JSP25-02 CAMELOT PARC TOWNHOMES

PLANNING REVIEW

PLAN REVIEW CENTER REPORT

Revised PSLR Concept Plan

STONEBROOK DRIVE MAINTENANCE CONTRIBUTION CALCULATION

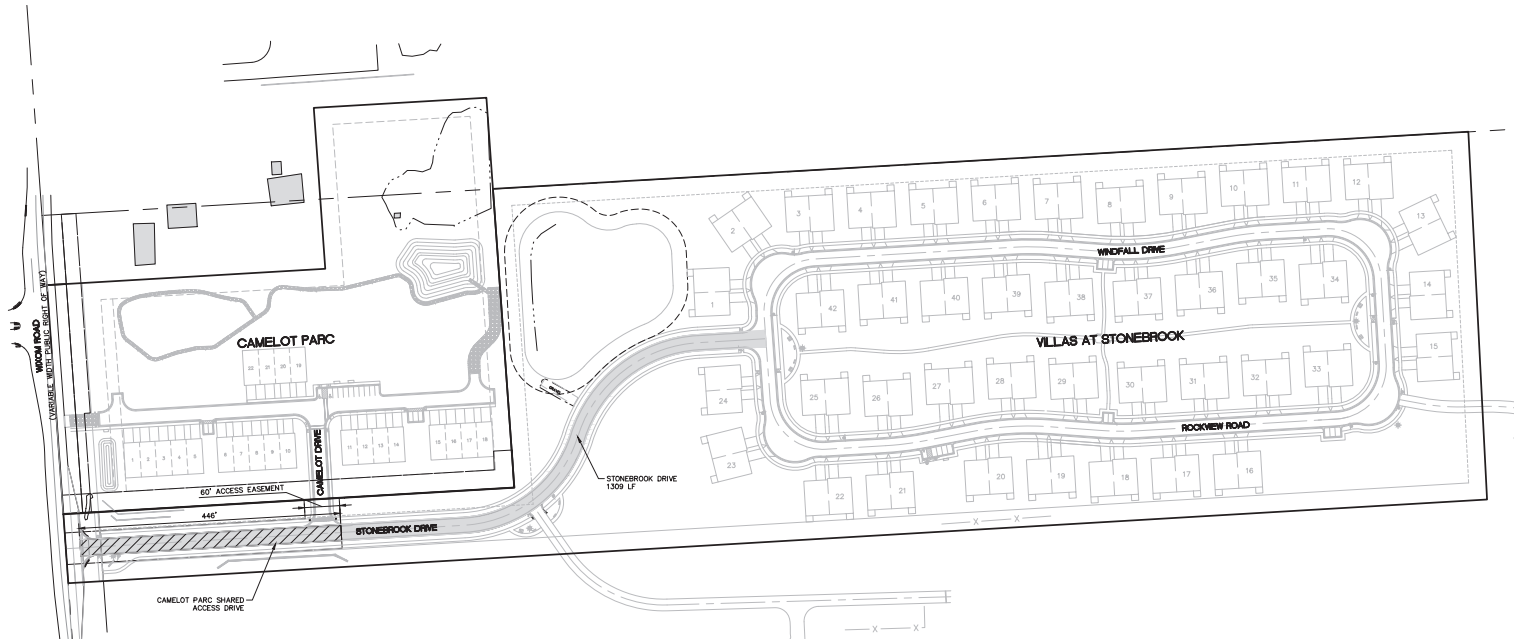
6. **Stonebrook Drive:** The applicant has included a proposed Road Maintenance Plan on Sheet 11 for Stonebrook Drive. The plan calculates a contribution for the proposed Camelot Parc toward Stonebrook Drive maintenance costs based on the length of the road, percentage of road used to access Camelot Drive, and the total number of units for each development. **As Stonebrook Drive is a private road owned by Villas at Stonebrook HOA, the applicant should meet with them to discuss proposed road maintenance agreement with them. Any cost sharing agreement would be a private agreement between the two entities.**

Requested Placement locations

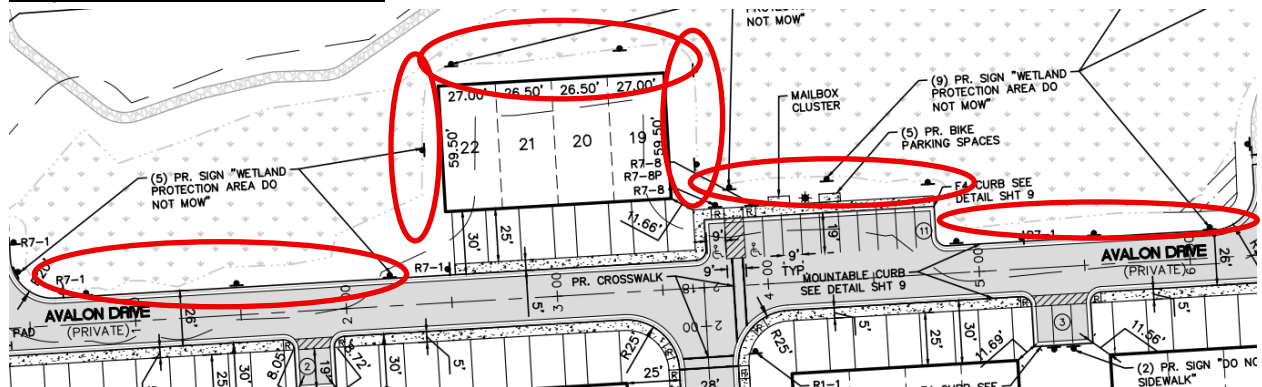
Due to the extensive proposed loss of wetland buffer along the southern remaining wetland area, it is requested that the applicant perform environmental enhancement along the southern portion of the remaining wetland (see screenshot below). The applicant should plant at least three different species of wetland rated shrubs throughout the southern boundary of the wetland. This will allow a small separation from the wetland and the proposed development. Additionally, it will deter any accidental mowing of the wetlands and remaining buffer areas. Shrubs could include three of the following species:

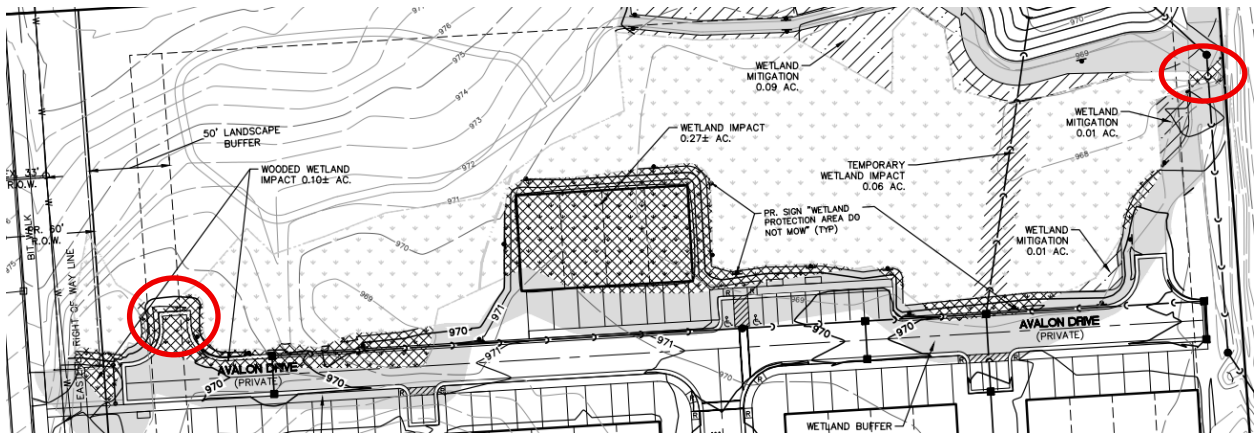
6. Portions of the wetland may become disconnected by the placement of fill throughout the site. It is requested that wetland equalizer culverts or similar structures be placed beneath roads that allow the wetlands on-site to remain connected. Specifically in the locations circled below.
